Subject: FRONT POWER SEATS DO NOT SLIDE BACK AND FORTH	Bulletin No: 09-006/16
	Last Issued: 02/03/2016

This bulletin supersedes the previously issued bulletin(s) listed below. The changes are noted in Red beside the change bars.

Previously Issued TSBs:
09-034/15

Power Slide Unit

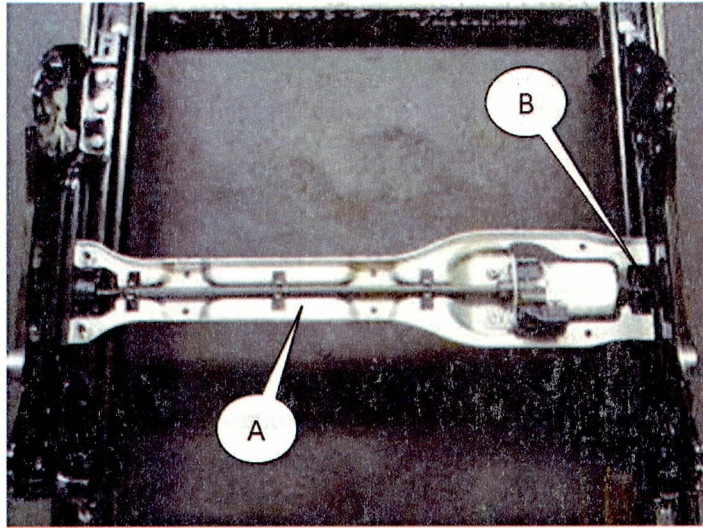
Some customers may complain that the front power (driver and/or passenger) seats do not slide back and forth properly or that they may be completely inoperative. This concern may be caused by a foreign object getting stuck under the power slide unit (below) while in operation. This can cause motor mounting bracket (A) deformation, resulting in motor cable (B) breakage.

To eliminate this concern, the shape of the motor mounting bracket (A) has been modified to increase its strength.

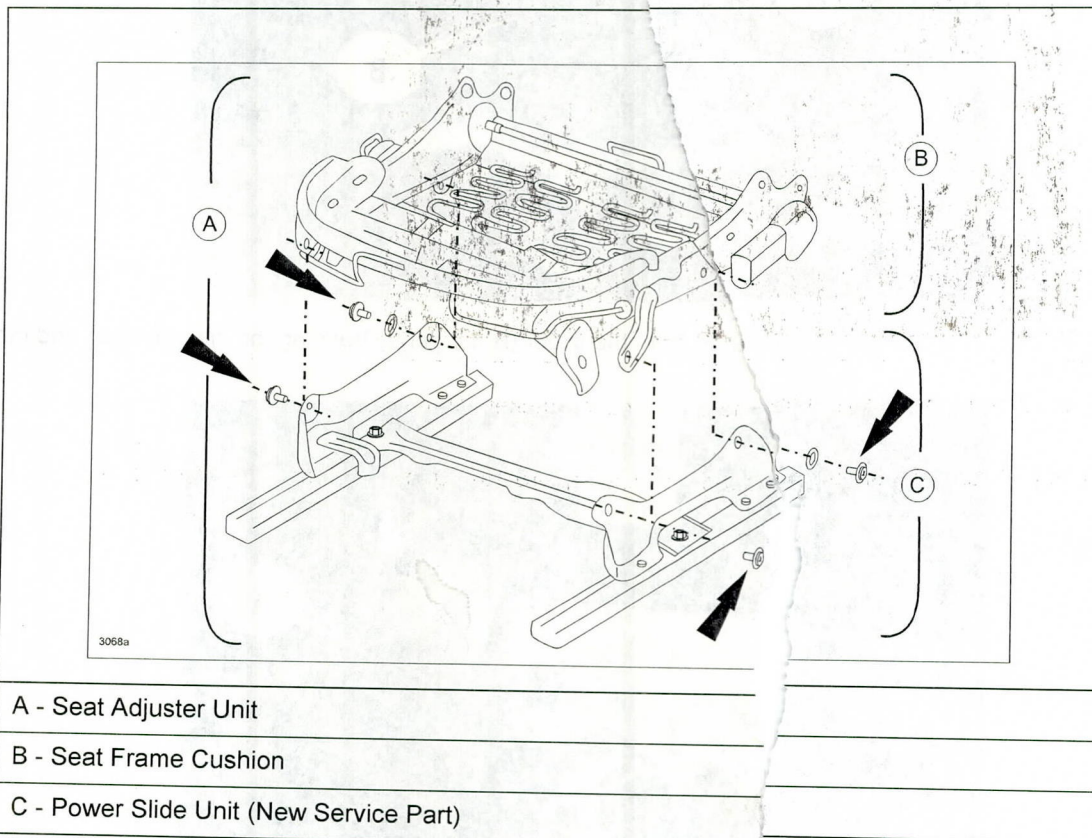
1. Verify the customer concern.
2. Inspect the motor cable (short one) and the motor mounting bracket:
 - Is the motor cable broken?
 - Is the motor mounting bracket deformed?
3. If the results are "Yes" for either of the above inspections, replace the power side unit with a newly established modified service part according to the replacement procedure.
